JRPP Ref. No.	2012SYE104
D/A No.	DA-390/2012
Property	2 Vermont Avenue and 13 Washington Avenue, Riverwood
Proposal	Demolition and construction of a mixed use building including an educational establishment, and a residential flat building comprising 27 social housing units and 68 privately owned units, car parking including basement car park, associated site works and subdivision.
Zoning	Residential 2(c4) under the Canterbury Planning Scheme Ordinance / R4 High Density Residential under Canterbury Local Environmental Plan 2012.
Applicant/Owner	Applicant – M Projects Pty Ltd Owner – NSW Land & Housing Corporation and Canterbury City Council
Report By	Sean Flahive - Development Assessment Officer

EXECUTIVE SUMMARY

Figure 5 – Road 1 and Road 2 (On street parking)

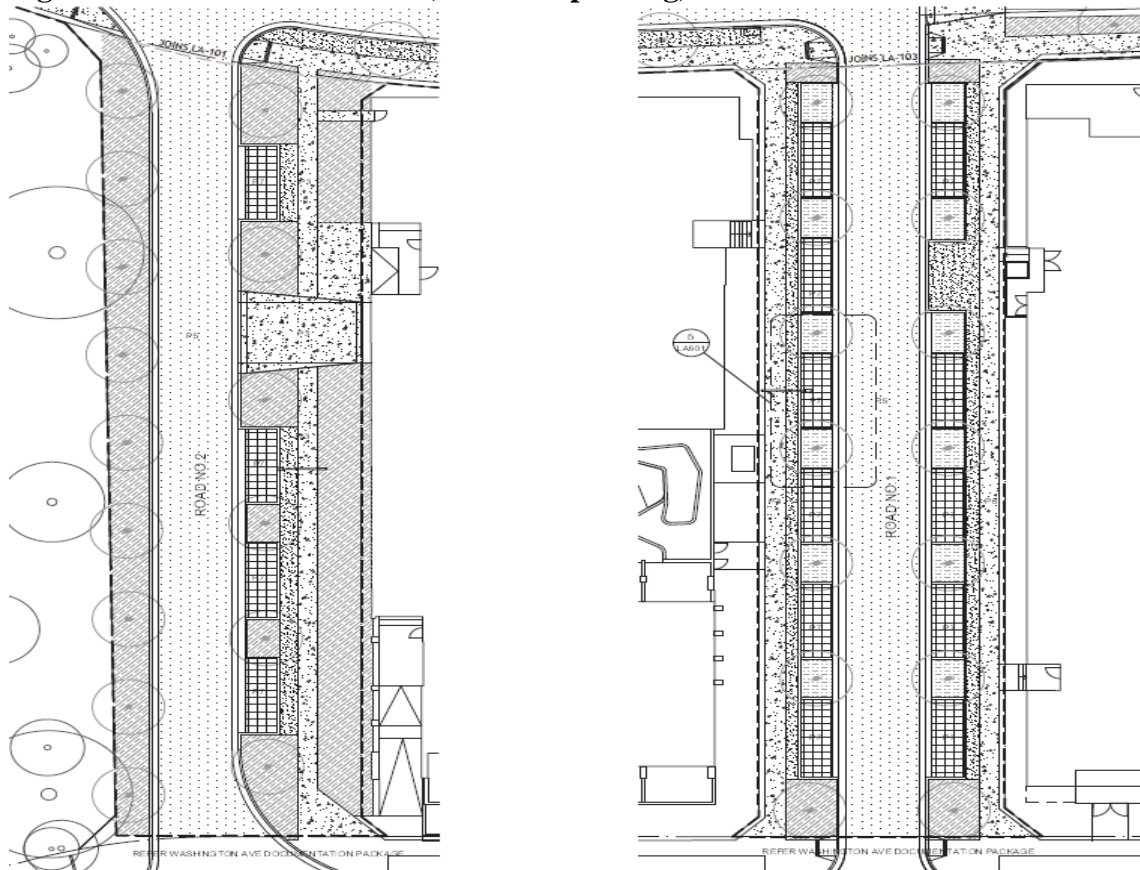
The other argument made by the applicant is that the availability of on street car parking in the vicinity could facilitate any additional parking generated by the educational establishments. In the documentation submitted that applicant states that *"additional on-*

street kerbside parking is to be provided in the two new roads 1 and 2, in addition to kerbside parking which is readily available in Washington Avenue.”

Figure 5 below indicates that the on street parking referred to equates to only 15 additional spaces, with the availability of these spaces, not guaranteed. It should also be noted that all on-street parking is proposed to be removed from Washington Avenue to facilitate the traffic control measures. Figure 6 below shows the substantial distance from these roads to the subject site. Given the limited number of on street car parking spaces available in the precinct and the distance of the on-street parking to the subject site, it is considered the reliance upon on-street parking to accommodate the parking generated by the proposed educational establishment is unacceptable.
